# Issue 18: What is Data Point's Point?

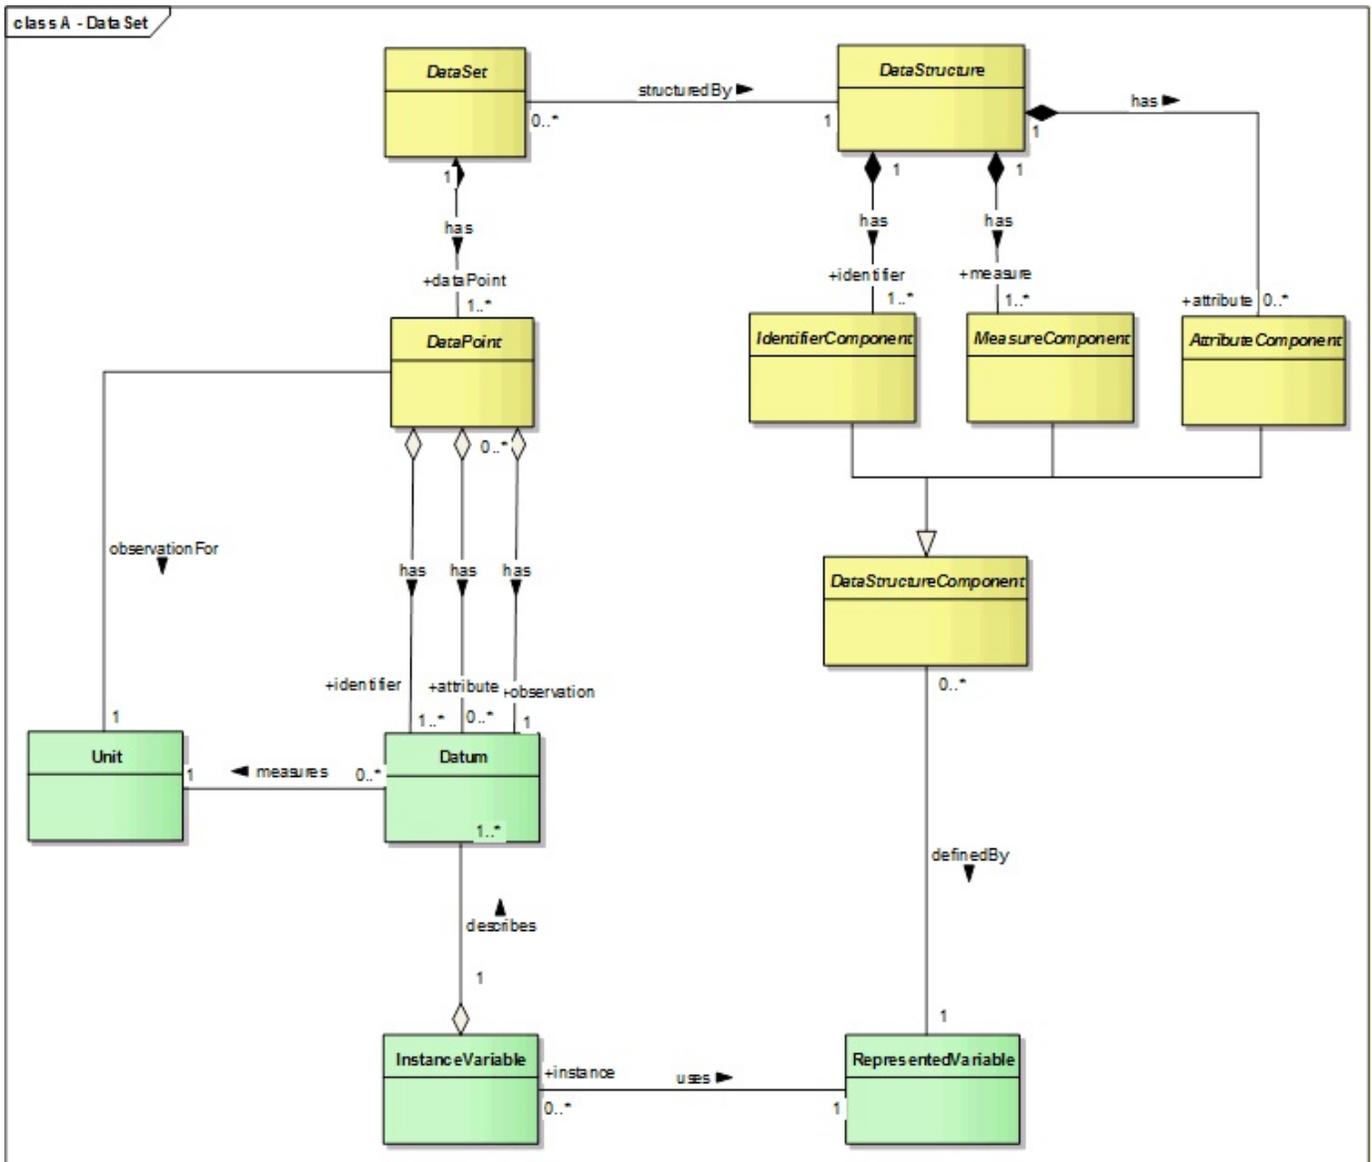
If we consider the above definitions of DataPoint and UnitDataPoint, then they say that it is a cell within a UnitDataSet. The example given within UnitDataPoint, and the corresponding class diagrams (ie fig 44, page 248) however, tend to indicate that DataPoint (just referring to the one for the rest of the discussion) is in fact a combination of information, which would be coming from multiple cells of data (ie, a 'row' of data).

If we go by the written definitions, that the DataPoint is a cell of data, then the example should show that it is the container to hold age in years (43, as per example above), not the combination of social security number and age. There would be another DataPoint which would hold the social security number (1212123) for that Unit.

Within the diagram, DataPoint has Datum (value) related to it in three ways - as an identifier, an attribute, or an observation (although this should be measure, based on the name of the equivalent Data Structure Component). According to the cardinalities in the picture for these three relationships, a DataPoint MUST have at least one identifier, MUST have at least one measure/observation, and may have one or more attributes. This seems to give an indication that the DataPoint covers more than one 'cell' of data. The example also indicates that it is a combination of information - as the DataPoint includes both the age and the social security number for the unit.

Proposal 1: We assume that the definitions of DataPoint, UnitDataPoint and Datum are correct, which means that the cardinalities between DataPoint and Datum are incorrect in Fig. 44?

Therefore, a DataPoint represents a single cell of data, and so the example has two DataPoints - one for age (43) and one for social security number (1212123).

Proposal 2: We assume that the definitions are incorrect, and the cardinalities in fig. 44 are correct. Therefore, a DataPoint represents all the data for a single Unit (ie, it is the whole 'row' of data, including both the age (43) and the social security number (1212123) for the Unit.

1. Is the information shown in fig. 44 only correct for dimensional data, and so is wrong in the case of unit data?
2. A diagram showing the relationships and cardinalities between UnitDataPoint, UnitDataSet, UnitDataRecord and Datum would be helpful in clarifying things (ie, a combination of the information that is currently split between fig 44 and fig 45 in GSIM v1.0 (pages 240 and 250 respectively).
